**ADDENDUM NO. TWO (2)
TO
COMMERCIAL APRON EXPANSION
HILTON HEAD ISLAND AIRPORT
HILTON HEAD ISLAND, SOUTH CAROLINA
IFB # 060420HXD
TBE PROJECT NO. 2119-1906**

June 5, 2020

CONSTRUCTION SAFETY AND PHASING PLAN
COMMERCIAL APRON EXPANSION

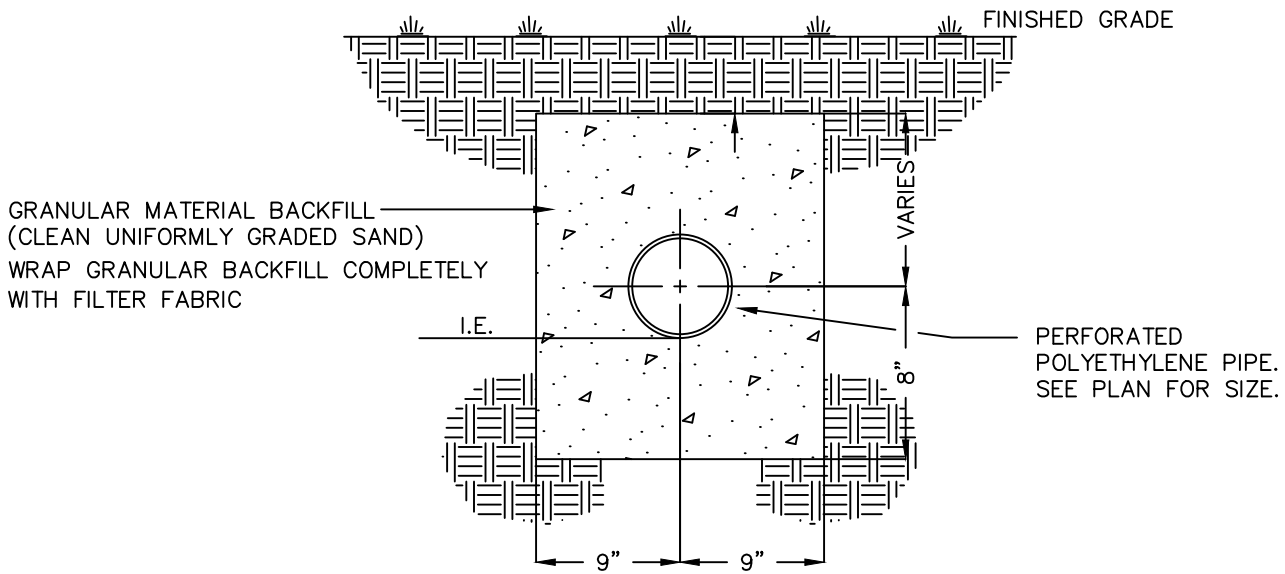
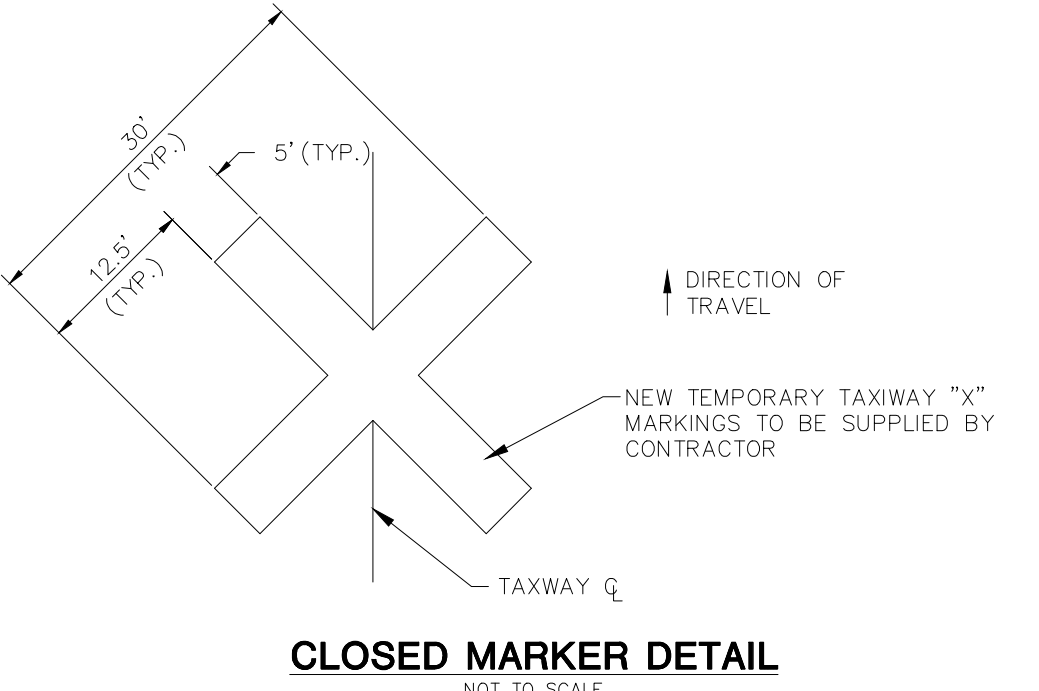
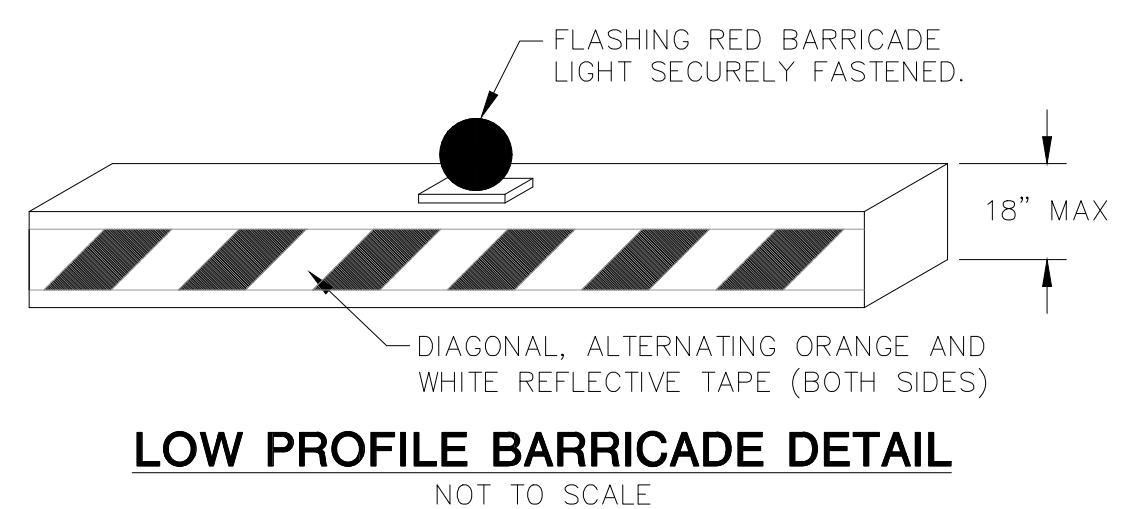
1. **REMOVE AND REPLACE** the original plan sheet 150 with the revised plan sheet 150 attached to this Addendum.
2. **MODIFY** plan sheet 451 by **ADDING** the detail shown on “Underdrain Detail - Addendum 2” attached to this Addendum.
3. **REMOVE AND REPLACE** the original plan sheet 650 with the revised plan sheet 650 attached to this Addendum.

2. Question: Will a FOD barrier be required around the perimeter of the site adjacent to Taxiway F and Parking Apron?
Answer: See revised plan sheet 150 attached to this Addendum for the FOD barrier requirements associated with the temporary SIDA fence shown on the revised sheet 150.

TEMPORARY SIDA FENCING NOTES

- THE CONTRACTOR SHALL INITIALLY CLEAR AND GRUB ONLY ENOUGH TREES ALONG THE SOUTHERN PROPERTY LINE TO INSTALL THE TEMPORARY CONSTRUCTION ENTRANCE, SEDIMENT AND EROSION CONTROL MEASURES REQUIRED ALONG THE SOUTHERN PROPERTY LINE, AND THE PROPOSED AIRPORT SECURITY FENCE/DOUBLE SWING GATE. ONCE THESE ITEMS ARE COMPLETE AND THE AIRPORT SECURITY IS APPROVED BY THE OWNER, THE CONTRACTOR SHALL REMOVE THE EXISTING AIRPORT SECURITY FENCE SHOWN TO BE REMOVED ON SHEET 200. THE CONTRACTOR SHALL THEN INSTALL THE TEMPORARY SIDA FENCE INSTALLED IN PAVEMENT AND THE TEMPORARY MOVABLE SIDA FENCE DEPICTED ON THIS SHEET. THE TEMPORARY SIDA FENCE INSTALLED IN PAVEMENT AND THE TEMPORARY MOVABLE SIDA FENCE SHALL BE CONSTRUCTED WITH THE SAME FENCE POST, CHAIN LINK FENCE FABRIC, BARBED WIRES/SUPPORT ARMS AND RELATED HARDWARE AS SHOWN ON SHEET 650. EXCEPT THESE TEMPORARY SIDA FENCES MAY BE CONSTRUCTED WITH STANDARD GALVANIZED COATINGS. ALL SIDA FENCES SHALL HAVE A SINGLE ROW OF TEMPORARY SIDA FENCE INSTALLED AND SECURED ALONG THE BOTTOM PORTION OF THE CHAIN LINK FENCE FABRIC AS A FOREIGN OBJECT DEBRIS (FOD) BARRIER. THIS FOD BARRIER SHALL BE MAINTAINED BY THE CONTRACTOR FOR THE DURATION OF THE PROJECT. ANY TEARS/HOLES/ETC. SHALL BE REPAIRED BY THE CONTRACTOR AT NO ADDITIONAL COST. USE SILT FENCE FABRIC MEETING THE REQUIREMENTS SHOWN ON SHEET 401.

- ALL WORK/MATERIALS/MEN/EQUIPMENT/ALL INCIDENTALS ASSOCIATED WITH PROVIDING AND INSTALLING THE TEMPORARY SIDA FENCES, MAKING MULTIPLE MOVEMENTS OF THE TEMPORARY MOVABLE SIDA FENCE DURING CONSTRUCTION, SIDA FENCE/FOD BARRIER MAINTENANCE, REMOVAL OF ALL TEMPORARY SIDA FENCES AND DISPOSAL OFF-AIRPORT, AND RESTORATION OF EXISTING PAVEMENTS AS LISTED IN THE "TEMPORARY SIDA FENCE IN EXISTING PAVEMENTS DETAIL" ON SHEET 650 SHALL BE INCIDENTAL TO THE "REMOVE EXISTING FENCE" ITEM OF WORK. NO SEPARATE PAYMENT WILL BE MADE FOR TEMPORARY SIDA FENCES.
